**Technical Service
BULLETIN**

Title:
REAR HEADLINER RATTLES
Models:
'03 4Runner

**NV/H
NV011-02**

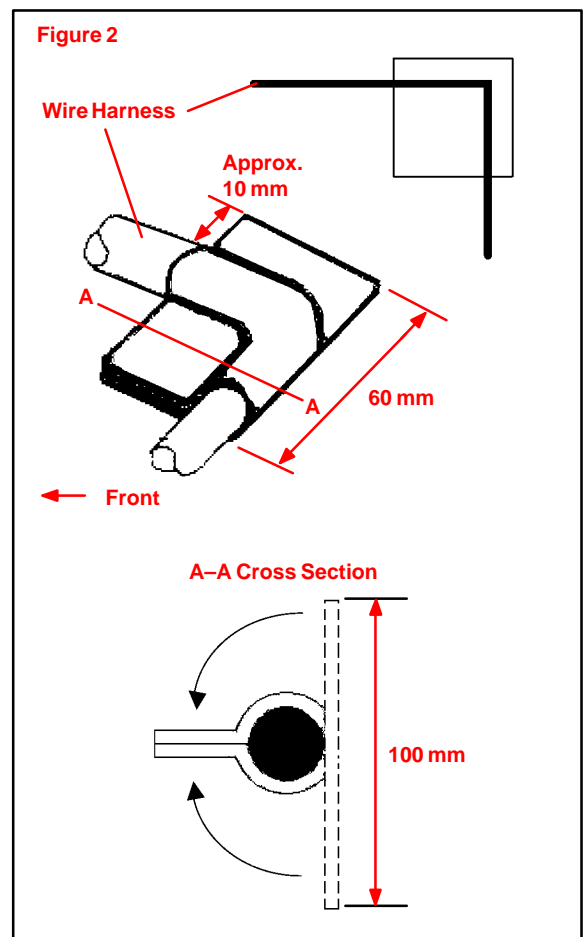
- A. Wrap wire harness as shown in Figure 2 with urethane sponge material (position “2A,” Figure 1).

NOTE:
If urethane sponge material is not available in the following size, patch multiple pieces together.

Urethane Sponge
L: 60 mm
W: 100 mm
T: 5 mm

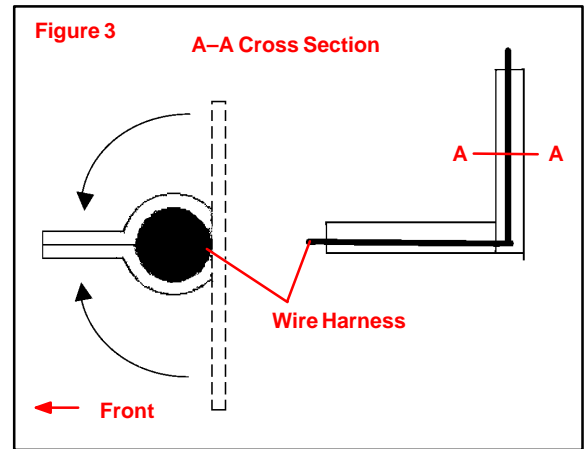
B. Wrap wire harness as shown in Figure 3 with urethane sponge material (position 2B, Figure 1).

NOTE:
If urethane sponge material is not available in the following size, patch multiple pieces together.

Urethane Sponge
L: 110 mm
W: 40 mm
T: 5 mm

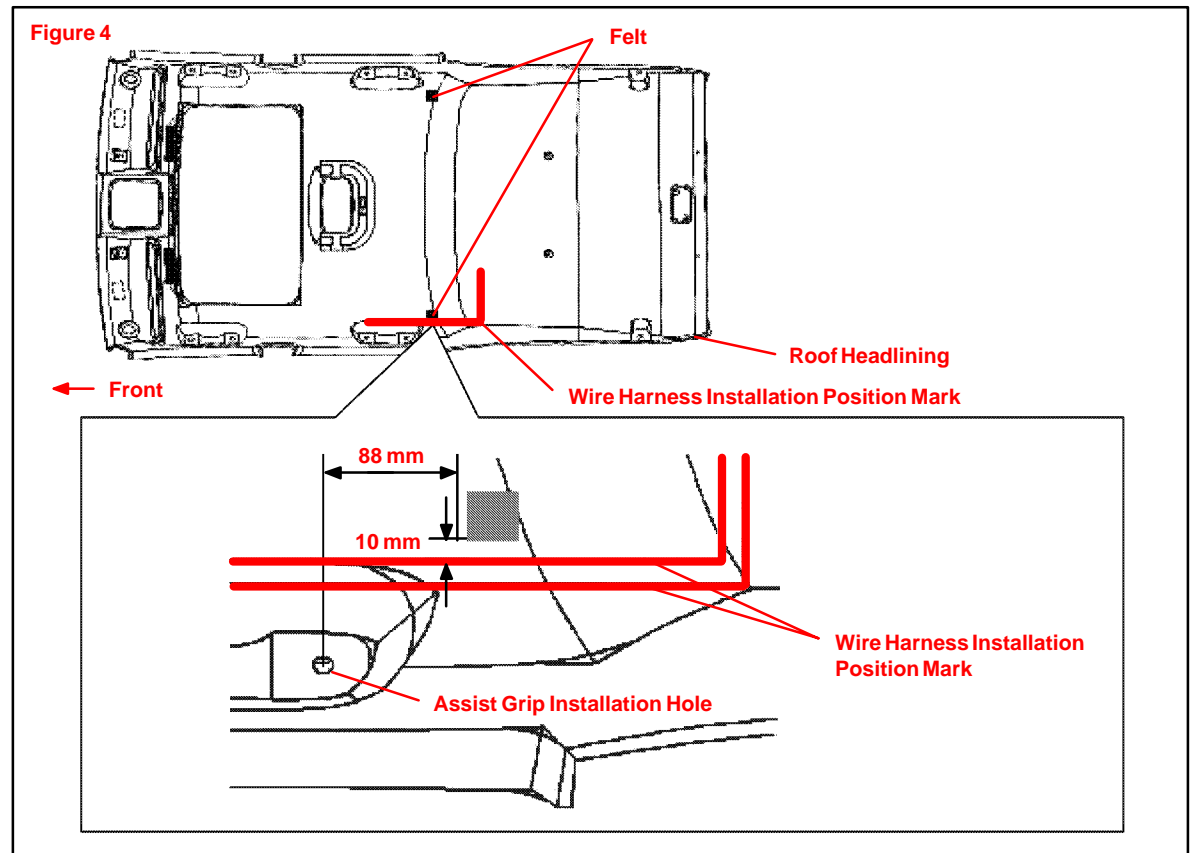
3. Fit two pieces of felt material to the upper roof headlining.

NOTE:
If 3 mm thick felt material is not available, layer multiple pieces to obtain the correct thickness.

Felt
L: 30 mm
W: 30 mm
T: 3 mm
